IN THE DRAWINGS:

The Applicant respectfully requests that the Examiner approve the changes to Figs. 1, 2, 10, 14 and 18 as indicated in red ink on the enclosed four (4) sheets of drawings. The proposed changes are in response to the Examiner's objections as indicated in the Office Action dated June 24, 2002.

REMARKS

FIG. 1

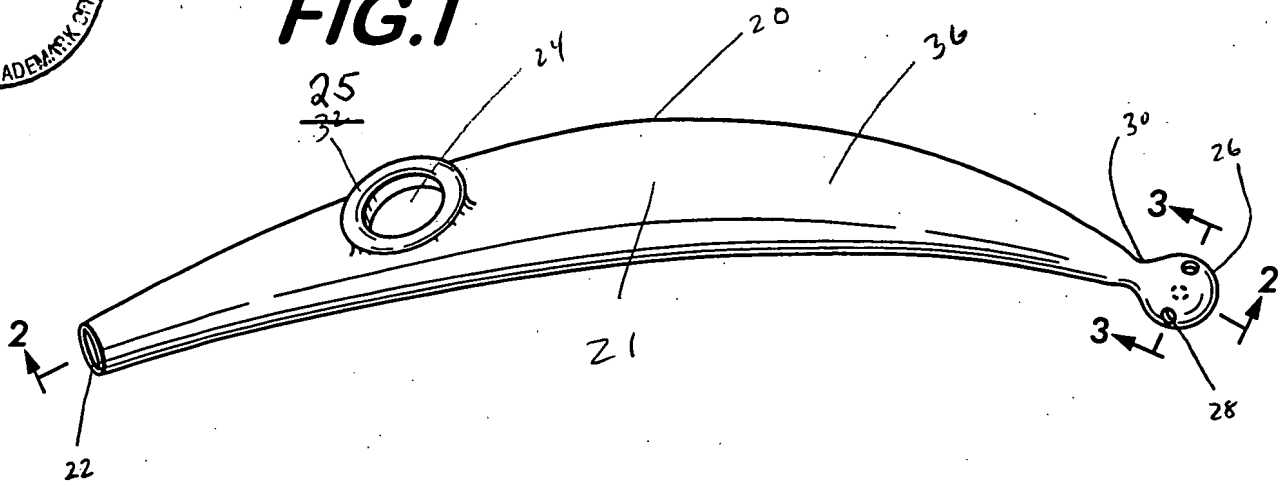
The Examiner objected to Fig. 1 because element 32 is designated in Fig. 1 but is not mentioned in the Specification. In Fig. 1, element 32 includes a lead line pointing to a raised ring. In the Specification at page 10, line 3, this raised ring is designated as element 25. Thus, the drawing has been modified by replacing the designation 32 with the designation 25 to agree with the Specification.

FIG. 2

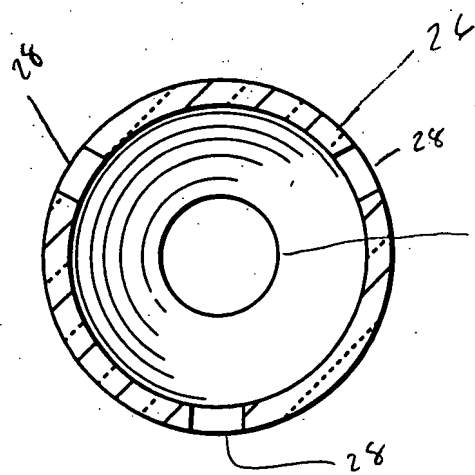
Next, the Examiner objected to Fig. 2 because element 18 designated therein has no support in the Specification. Upon close inspection, it is apparent that the element referred to by the

Examiner in Fig. 2 as "18", in fact, is a less than perfect rendition of a 28 corresponding to the vent hole. This designation in Fig. 2 has been modified to clearly show this element as a 28, not an 18.

FIG.10

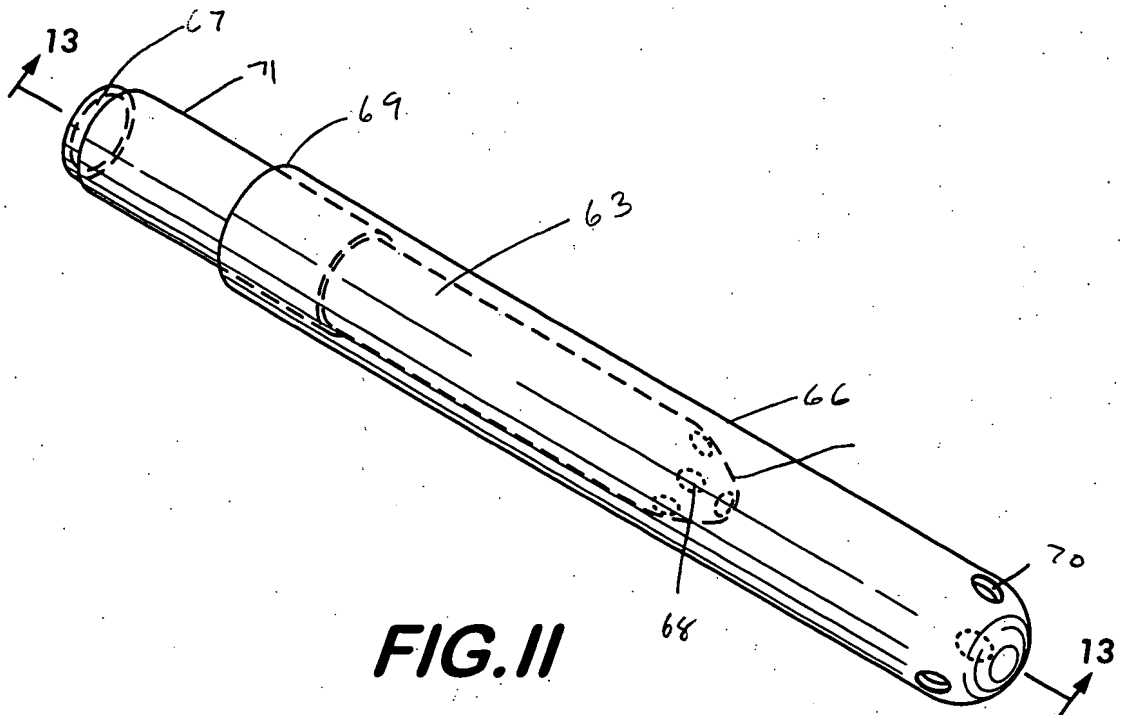
Finally, the Examiner objected to the drawings on the basis that element 57 in Fig. 10 designates different structure than described in the Specification, page 13 line 22 to page 14 line 1. In Fig. 10, element 57 is actually indicated twice. One of the designations 57 has been corrected to indicate element 53, i.e., the second hollow member.

FIG.14

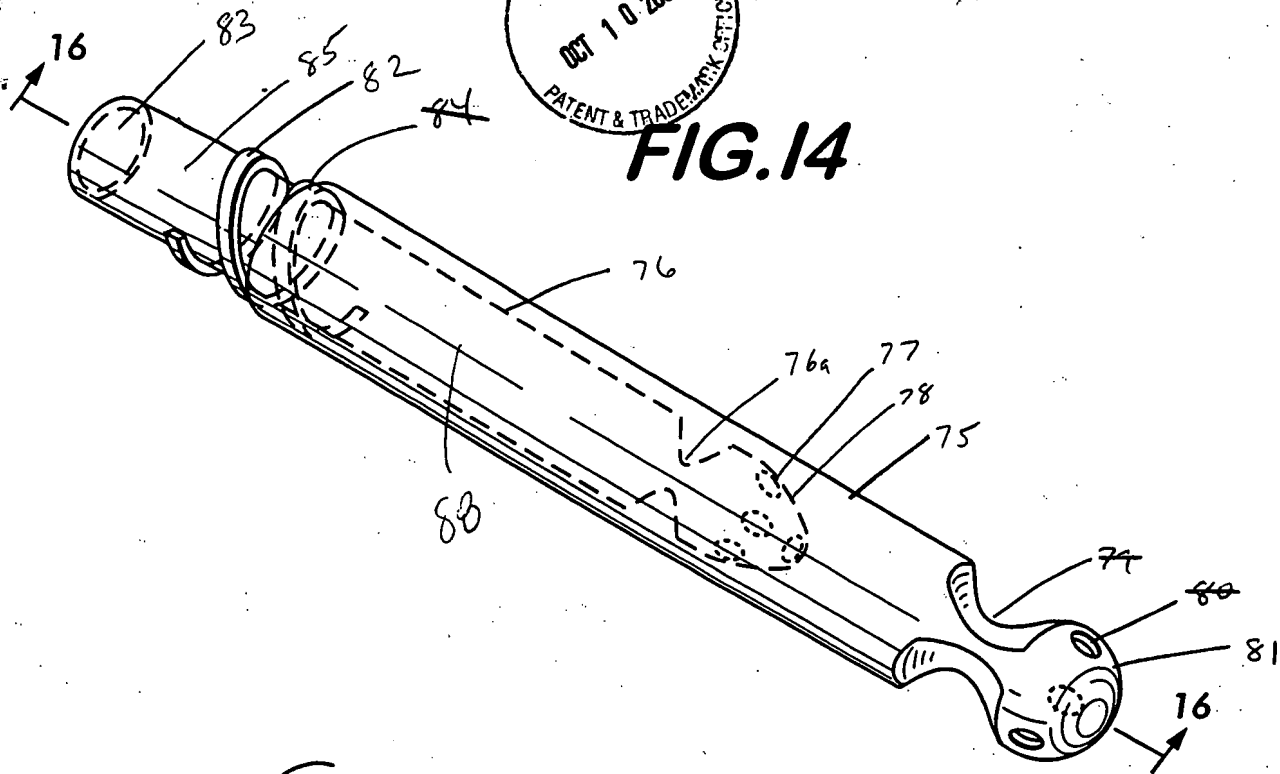
Next, the Examiner objected to Fig. 14 on the basis that elements 79, 80, and 84 designated in this figure are not referred to in the Specification. These reference numbers have been removed from this figure to overcome this objection.

FIG.18

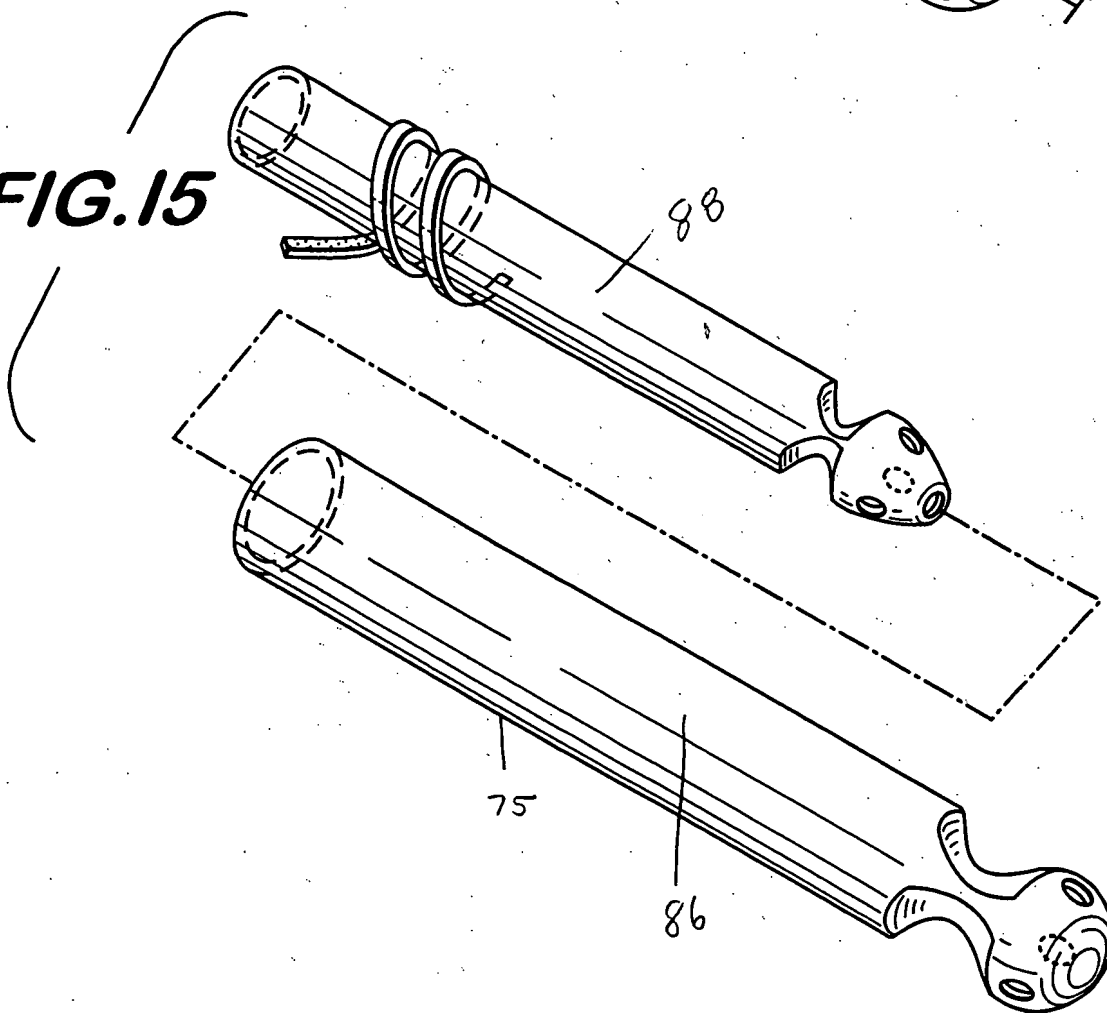
The Examiner has objected to the drawings on the basis that element 108 has been used in Figs. 18 and 19 to designate different structures. In Fig. 19, element 108 designates smoking materials. This designation is supported in the Specification in several places including page 19, lines 2 and 4. In Fig. 18, element 108 designates the adhesive layer on the inner surface of the retention bearing 104. This designation is supported in the Specification on page 18, line 11. Fig. 18 has been modified to replace the designation 108 with the designation 121. Likewise, at page 18, line 11, the Specification has been amended to indicate that element 121 refers to the adhesive layer on the inner surface of the retention bearing. In this manner, element 108 designates only one structure, i.e., smoking materials, and element 121 designates only one structure, i.e., the adhesive layer.

The third hollow member 94 has a narrow strip retention bearing 104 exposed around its proximal end. The inner surface [108] 121 of the retention bearing also includes an adhesive material to be affixed to the third hollow member 94.
